MEETING AGENDA

Planning and Zoning Commission

Village of Homewood

APPLICANT	Mahmoud Essa
ACTION REQUESTED	Site Plan Review, Special Use Permit
ADDRESS	18240 Harwood Avenue
PIN	29-31-312-007; 29-31-312-012; 29-31-312-020

2 SITE PLAN
1/16" = 1'-0"

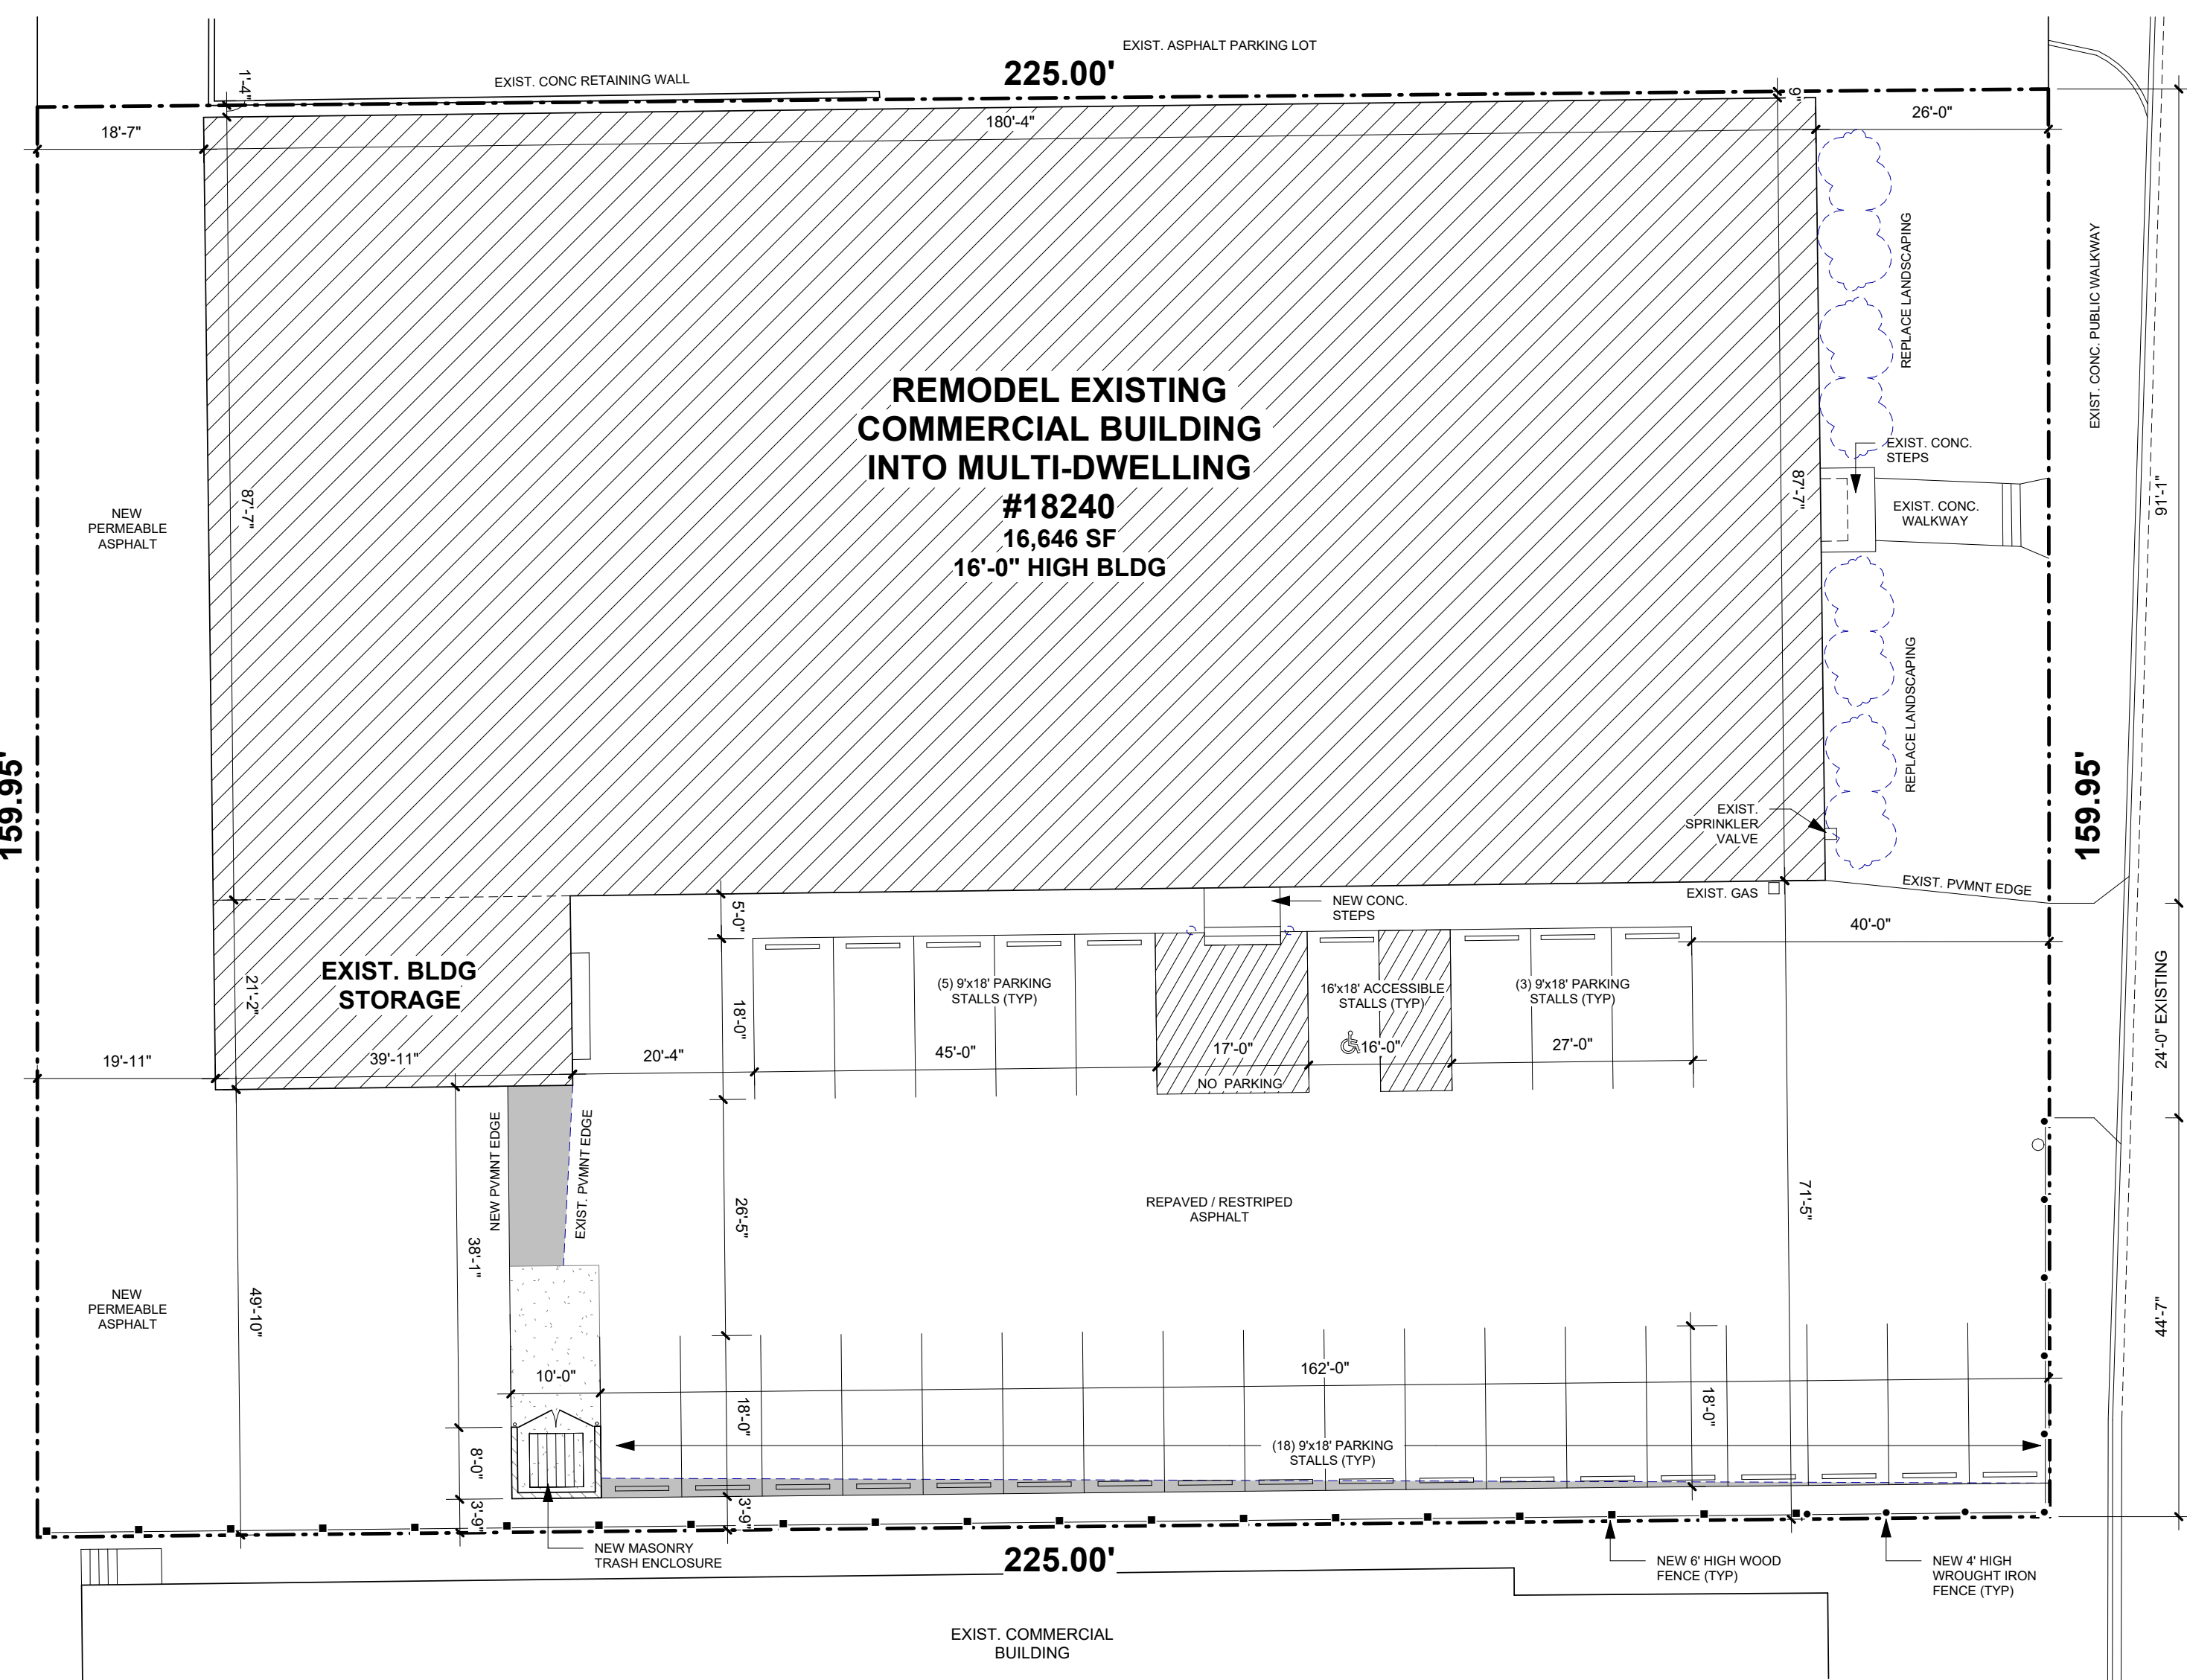
Per the 2018 Illinois Accessibility Code, a building with no “Type A” (fully accessible) units and assigned vehicle parking, is required to provide one (1) accessible parking space. One ADA-accessible space is provided. The site meets the Illinois accessibility requirements.

Vehicular access will be provided from an existing driveway on Harwood Avenue. No modifications are proposed to the driveway. The Village Engineer has approved the design of the driveway.

The applicant plans to install a new trash enclosure on the western (rear) side of the parking lot. The applicant has proposed to extend pavement to the west of the parking lot to accommodate truck access to the trash enclosure, in addition to installing a concrete pad in the front of the enclosure. The enclosure meets all screening and capacity requirements in Section 44-05-08 of the Zoning Ordinance.
